Findings of Fact | Wetland Conditional Use Permit

City of Portsmouth Planning Board

Property Address: 50 Odiorne Point Road

Re: Restoration Plan
Gardner Property: Stone Wall, Swale, and Vegetation Restoration Project
Portsmouth, New Hampshire

GARDNER PROPERTY RESTORATION PLAN
 NORMANDEAU ASSOCIATES, INC.
 PORTSMOUTH, NEW HAMPSHIRE

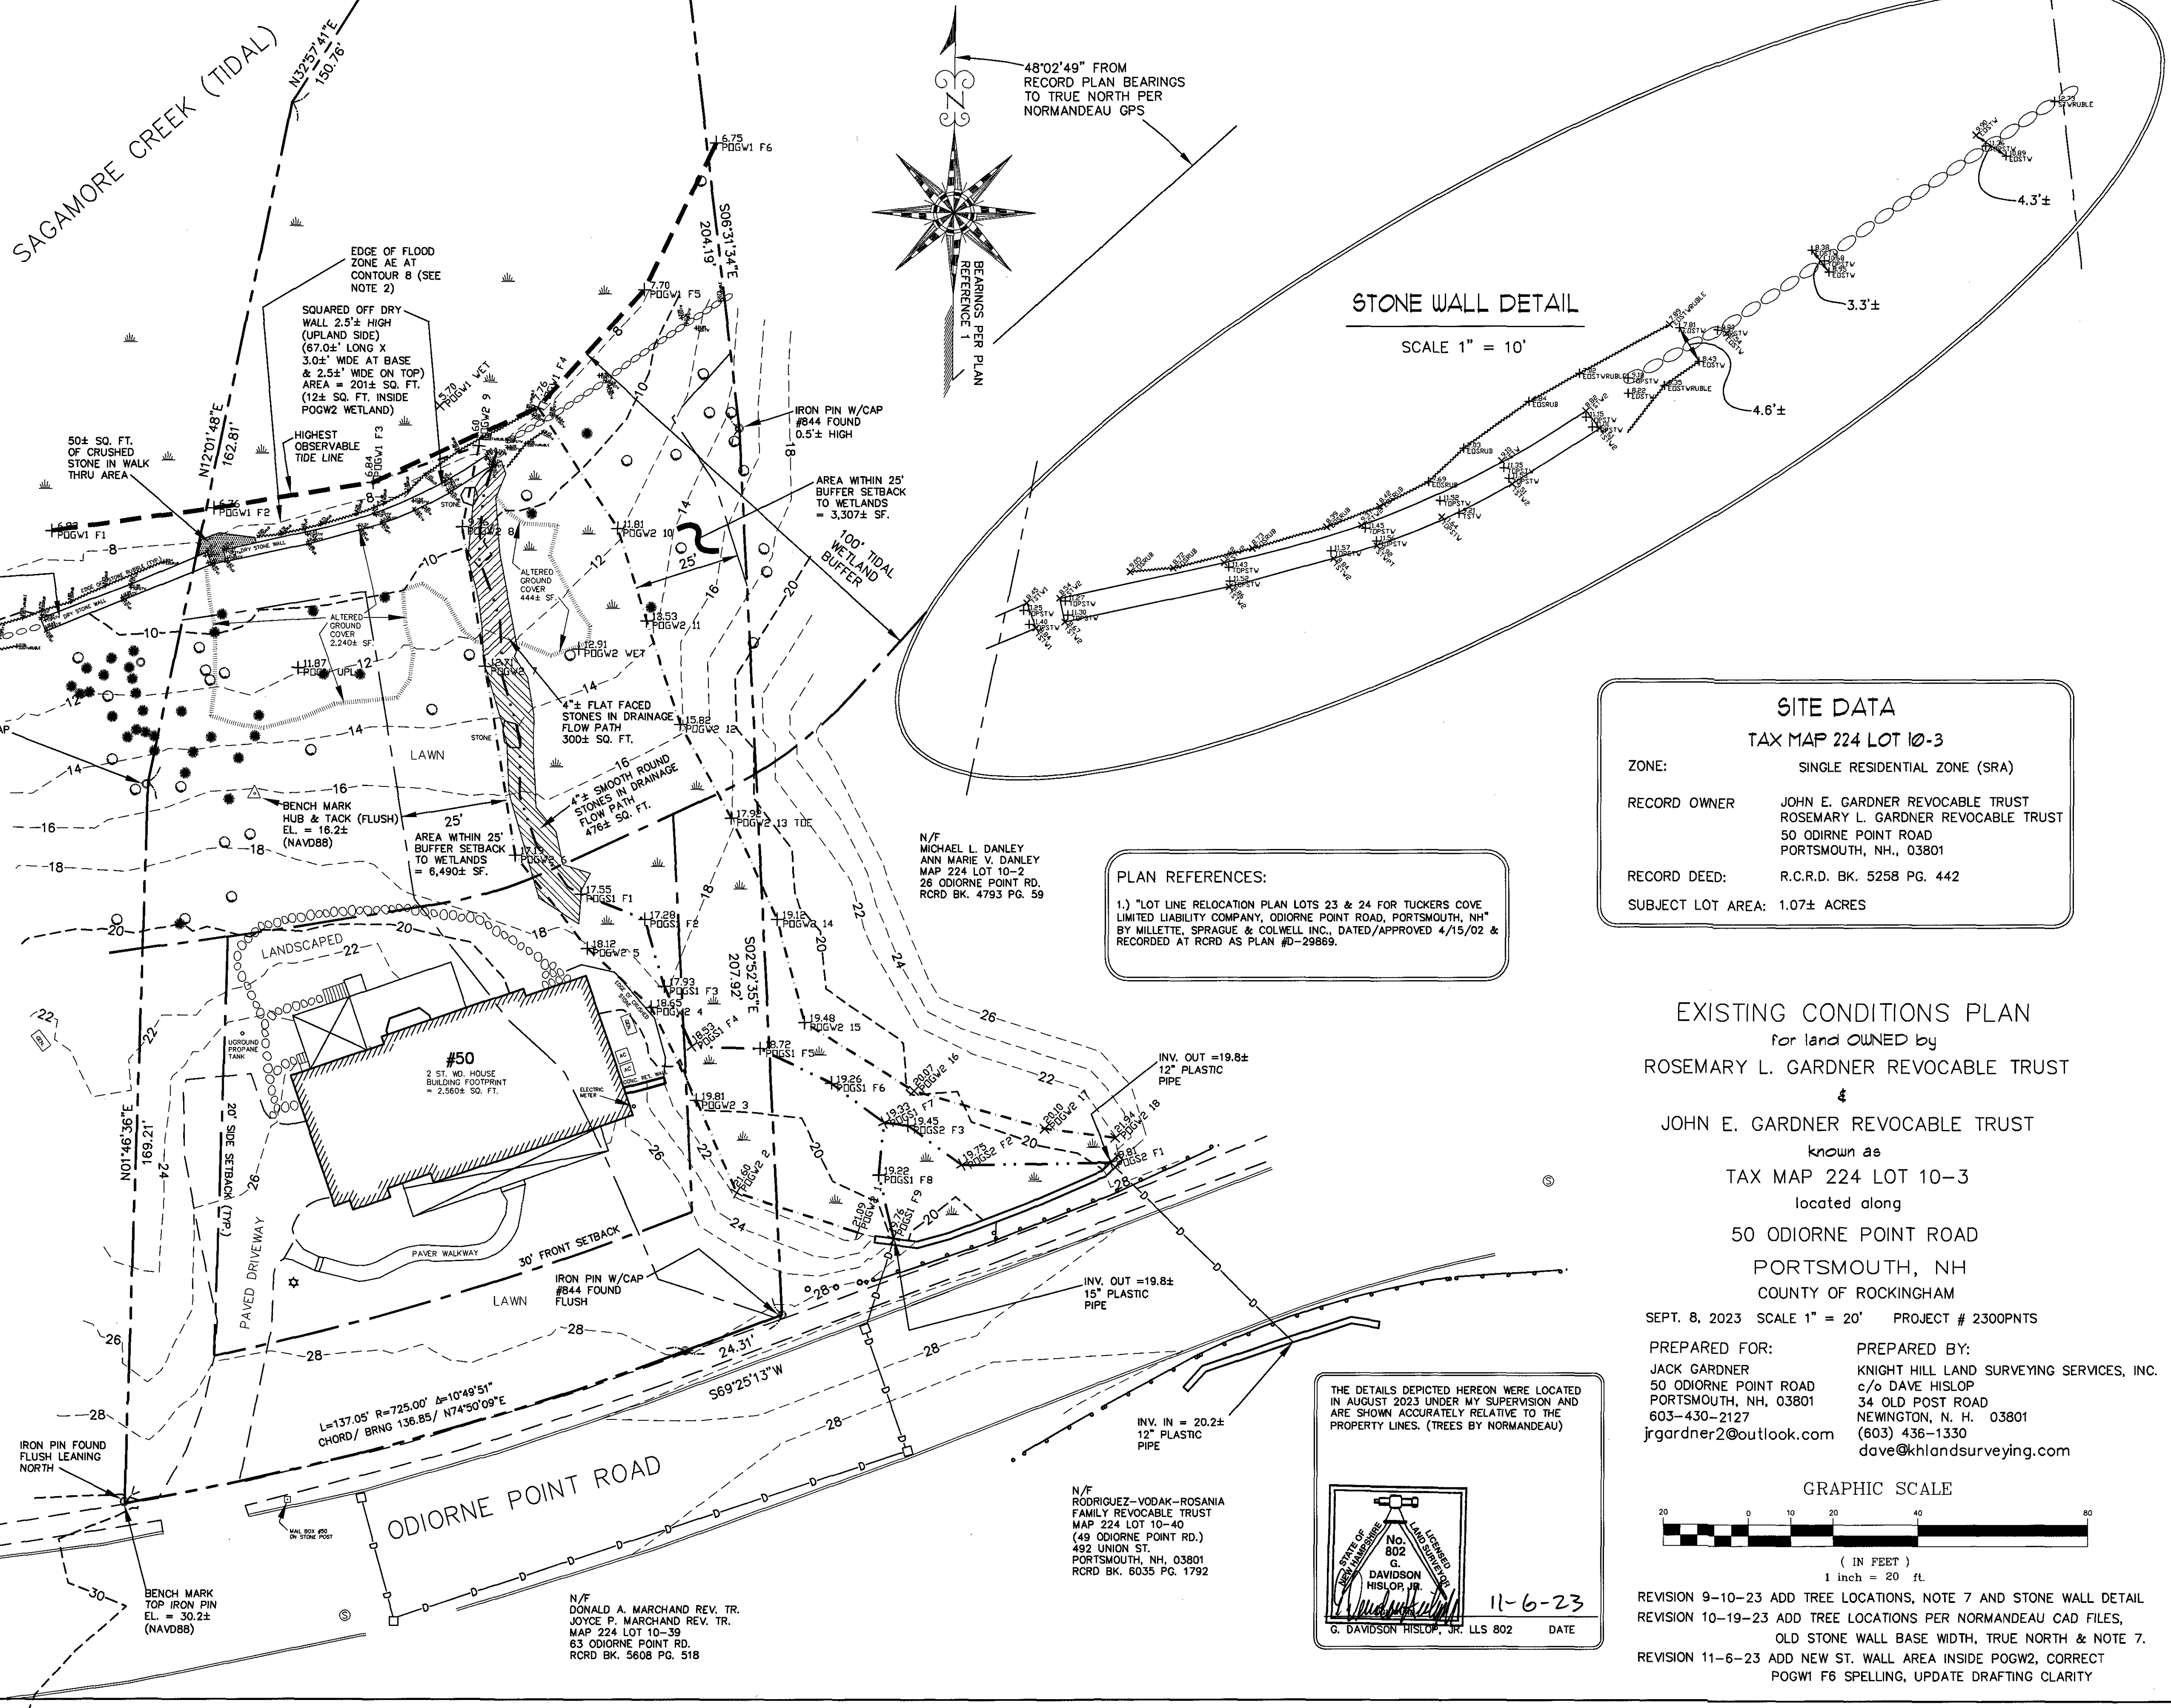
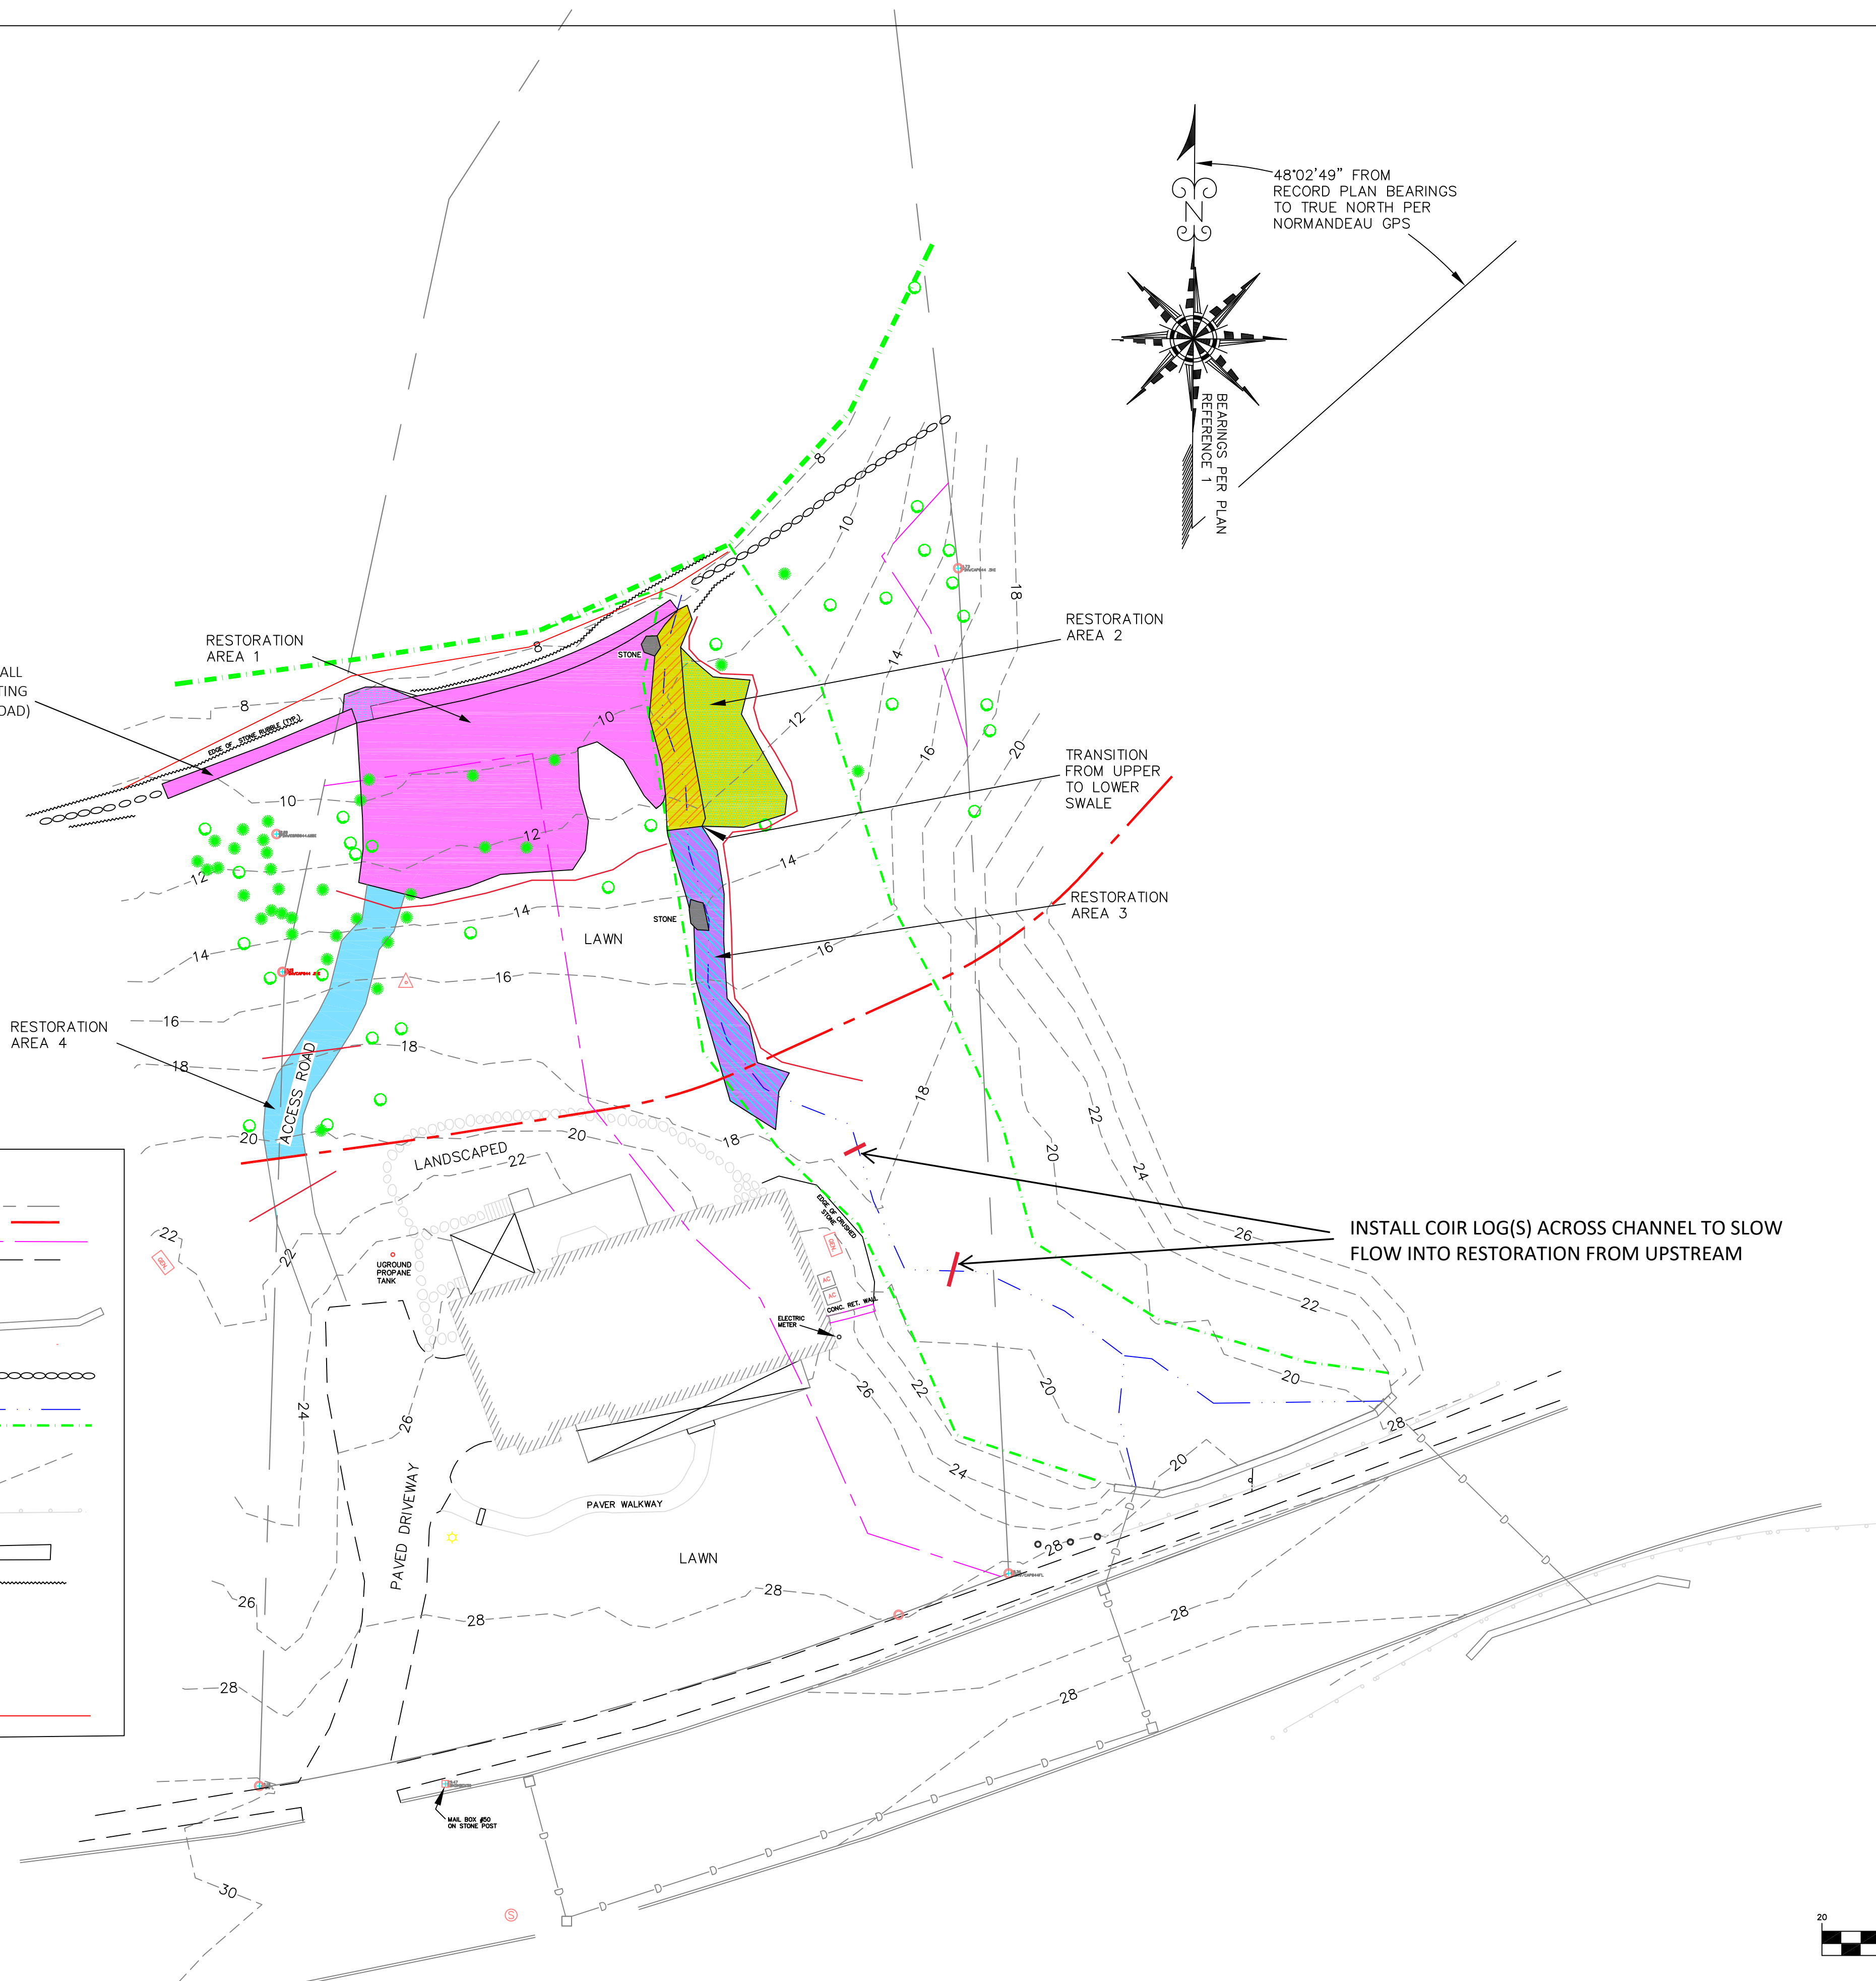
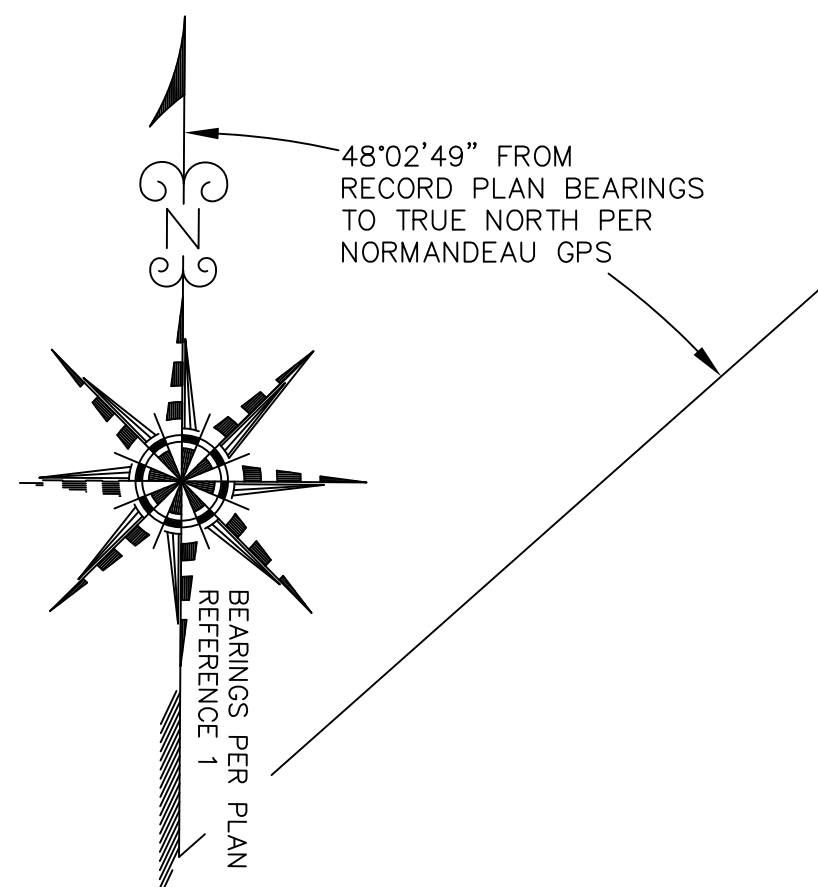
1. *The restoration plan shall be amended to include the addition of coir logs to protect the live stakes in the plant establishment phase.*

REVISIONS:
 ADDITION OF COIR LOGS ACROSS THE CHANNEL OF THE SWALE TO REDUCE FLOW VELOCITIES DURING LIVES STAKE ESTABLISHMENT PER STRIPULATION #1 OF THE PORTSMOUTH CONSERVATION COMMISSION DECISION LETTER. (02/21/24)

Project response: The project scope has been revised to include the installation of a minimum of six (6) coir logs across the existing channel of the swale as shown on Sheets 2 and 3 in Attachment B. Two of these coir logs will be installed during site set up to reduce flow velocities upstream of the restoration project, while the other four will be installed at intervals down the swale as stone is removed and live stakes installed. Coir logs will be positioned between live stakes with sufficient space to prevent them from pressing up against or touching the live stakes. All coir logs will be held in place using crossed wooden stakes rather than staking through the coir log itself, to maintain the integrity of the coir log. These coir logs will remain in place during live stake establishment and only be removed with the approval of Environmental Monitor for the project.
